Conservation revisions and confirmations:

PROJECT
PROPOSED REPAIRS AND WORKS TO OUTBUILDING AT HILDA COTTAGE SHELL HILL, ROBIN HOODS BAY

TITLE
SCHEME DRAWING
PLANS & ELEVATIONS

DWG NO. 955-01 REV C DRN RS

Proposed Front Elevation

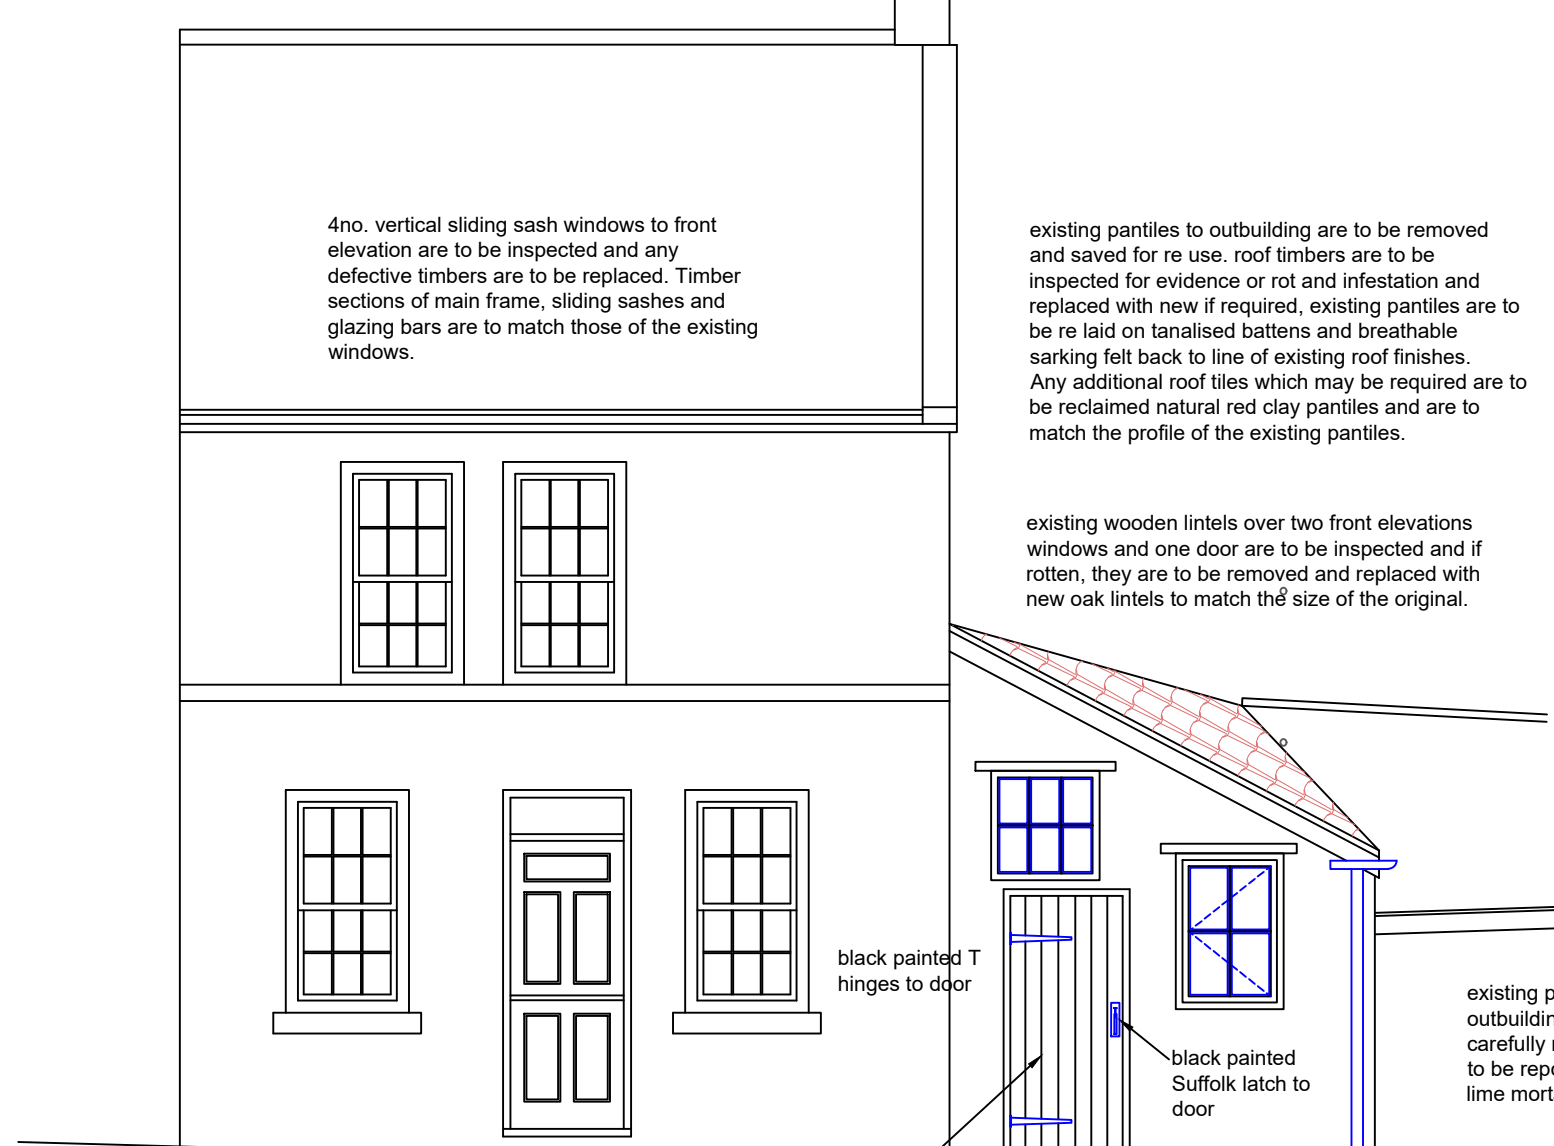
existing wooden lintels over two front elevations windows and one door are to be inspected and if rotten, they are to be removed and replaced with new oak lintels to match the size of the original.

2no. timber windows to front elevation are to be repaired as necessary, all new timber sections of main frame, opening sashes and glazing bars are to match those of the existing windows. Glazing is to be single glazed to maintain appearance of original windows.

existing paint to stonework of outbuilding to front elevation to be carefully removed and stonework is to be repointed with non hydraulic lime mortar.

existing rotten door and frame to front elevation of outbuilding is to be removed, new door and frame is to be manufactured and inserted into existing opening but secured in the closed position as a false door. details of door and frame to match those of the original door

Proposed Rear Elevation

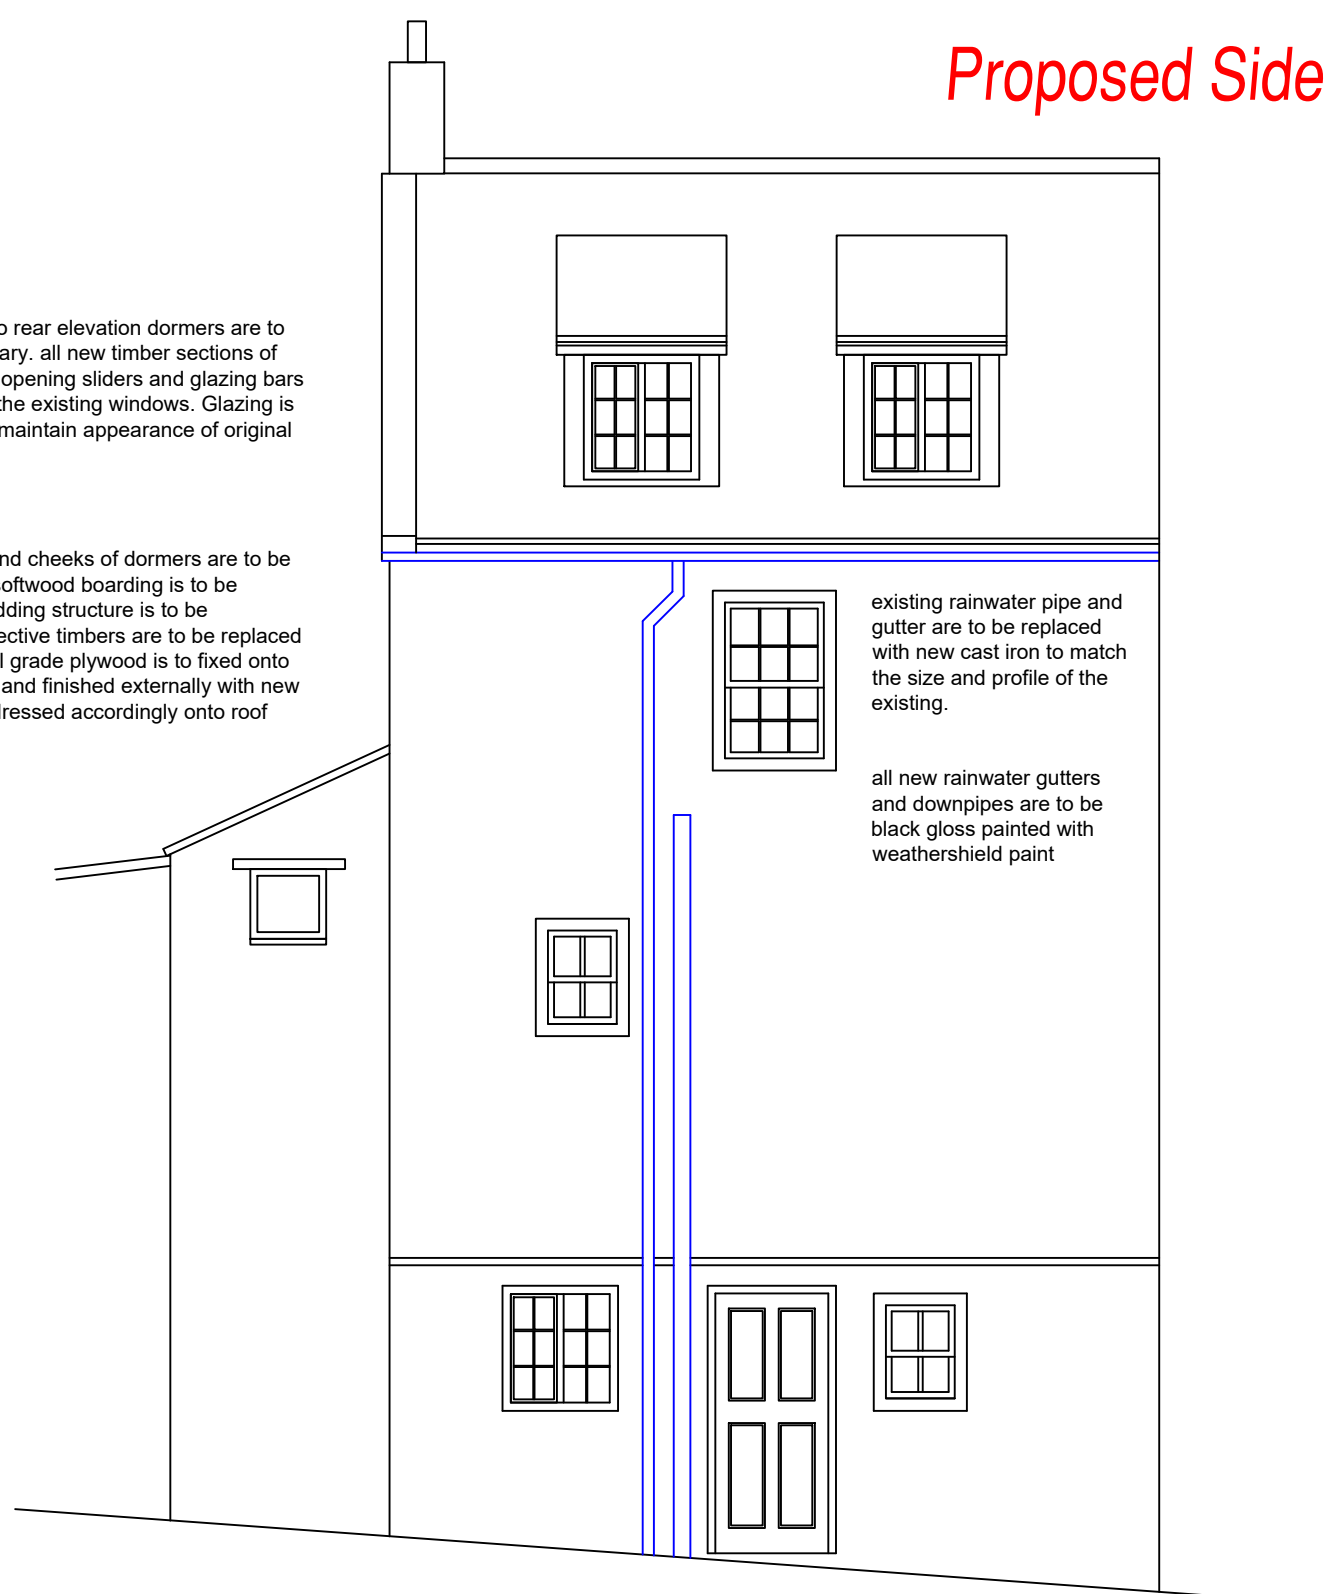
2no. timber windows to rear elevation dormers are to be repaired as necessary, all new timber sections of main frame, sideways opening sliders and glazing bars are to match those of the existing windows. Glazing is to be single glazed to maintain appearance of original windows.

all leadwork to faces and cheeks of dormers are to be removed, plywood or softwood boarding is to be inspected and any defective timbers are to be replaced with new. new external grade plywood is to be fixed onto breathable membrane and finished externally with new code 4 leadwork and dressed accordingly onto roof finishes

existing rainwater pipe and gutter are to be replaced with new cast iron to match the size and profile of the existing.

all new rainwater gutters and downpipes are to be black gloss painted with weathershield paint

section through false door

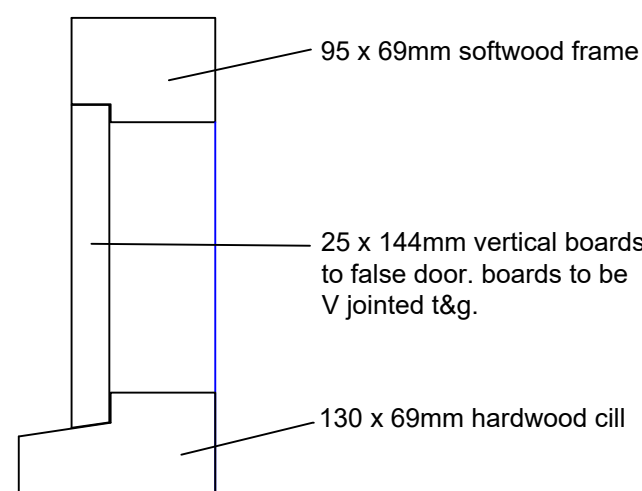
2. The windows to the store have been revised to be repaired rather than replaced.
3. the proposed ironmongery to the replacement door has been shown and also the proposed timber sections for the door and frame.

Proposed Section

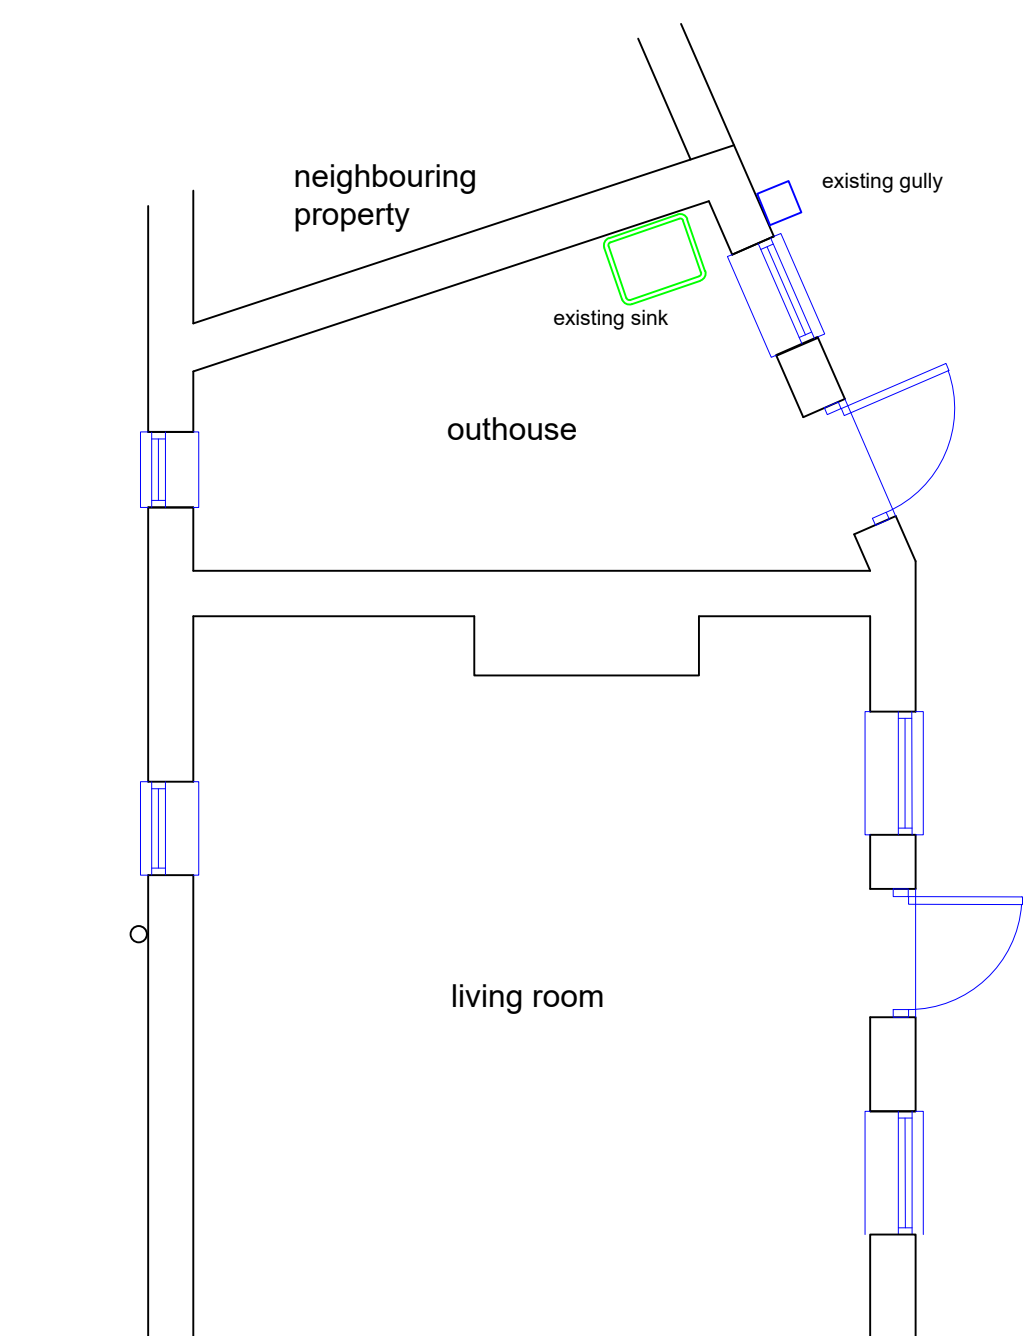
6. the proposed roof insulation has been revised to be sheeps wool insulation.
7. the rainwater goods to the rear elevation have been noted as being removed and replaced with new cast iron and to receive a black gloss painted finish.

Proposed Ground Floor Plan

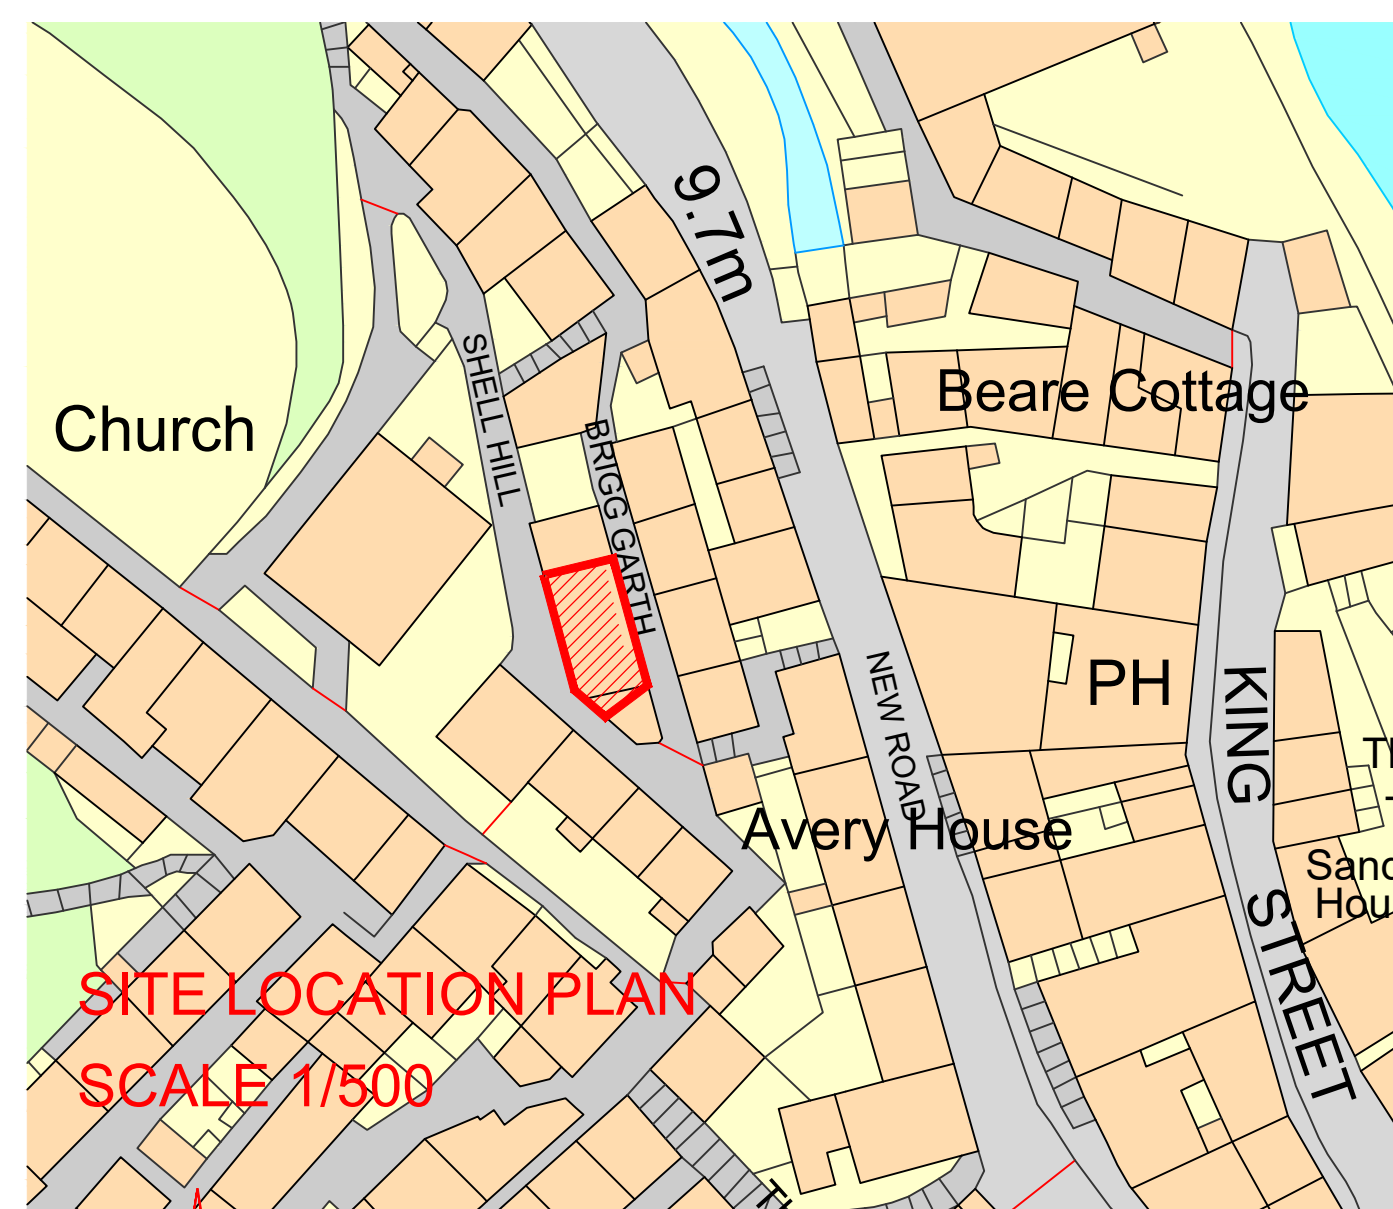
5. the proposed flooring has been revised to allow for the existing floor to remain and to be finished above the existing surface with a timber floating floor.
